# UNITED STATES PATENT AND TRADEMARK OFFICE

APPLICATION NO.	FILING DATE	FIRST NAMED INVENTOR	ATTORNEY DOCKET NO.	CONFIRMATION NO.
10/523,780	02/08/2005	Hiromunc Matsuoka	DK-US030323	5709

<b>Office Action Summary</b>	Application No. 10/523,780	Applicant(s) MATSUOKA, HIROMUNE	
	Examiner Tatiana Delorm	Art Unit 3744

## **DETAILED ACTION**

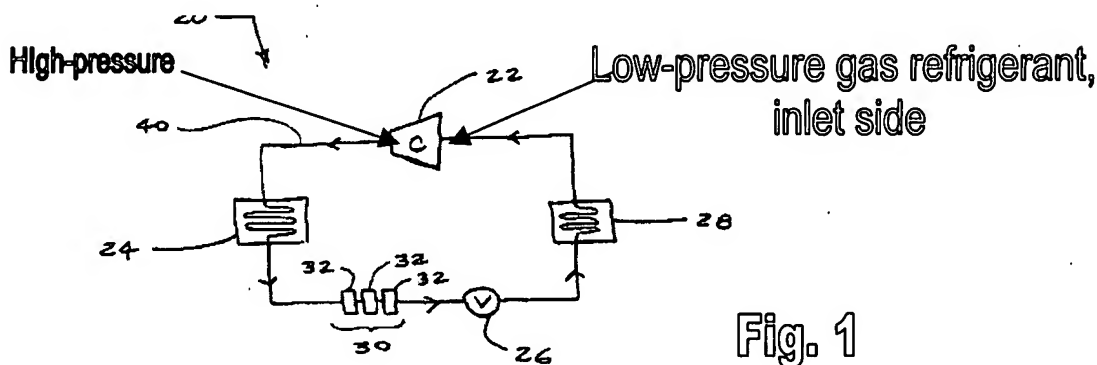
The applicant admits in the disclosure that the "standard working pressure is 2.0 MPa" and "a refrigerant having saturation pressure characteristics higher than R407C operates with pressure higher than 3.3 MPa (see page 6 of the specification).

Fig. 1a

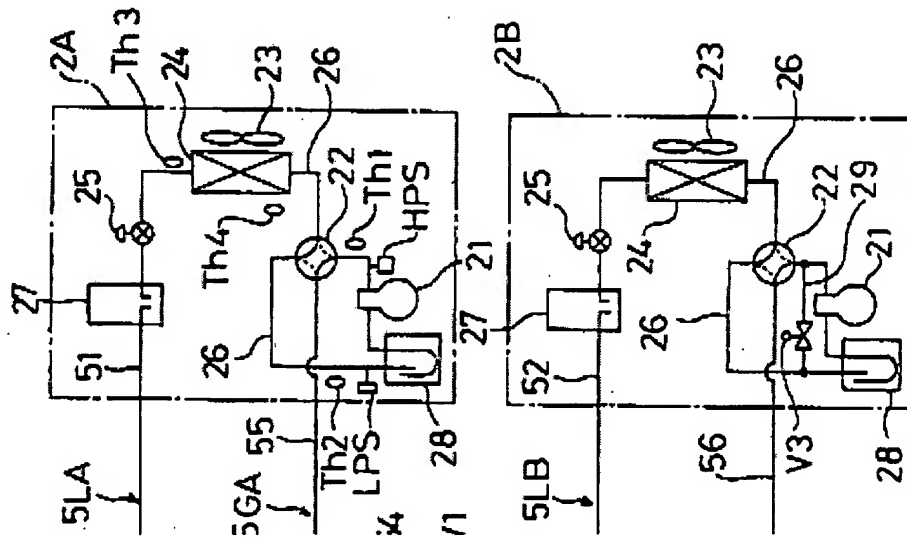
Sada teaches a plurality of utilization side (3A; 3B) heat exchangers (32) mutually connected (see lines 4L and 4G) in parallel (see Fig. 1) and arranged to operate as an evaporator (32); a switching mechanism (22) configured and arranged for switching between a state (Fig. 1); and a suction accumulator (col. 2, line 59) connected between said switching mechanism and the said inlet side of said compressor (see Fig. 1); said accumulator (28) connected between said switching mechanism and inlet side of said compressor (Fig. 1, col. 12, lines 1-3), said accumulator (28) configured and arranged for pooling low-pressure refrigerant (LPS) as a liquid refrigerant, said switching mechanism and the inlet side of the compressor forming a low pressure unit (as seen in the illustration of Fig. 1a);

and the compressor, said heat source side heat exchanger, said plurality of utilization side heat exchangers, and said switching mechanism forming a high pressure unit (Fig. 1).
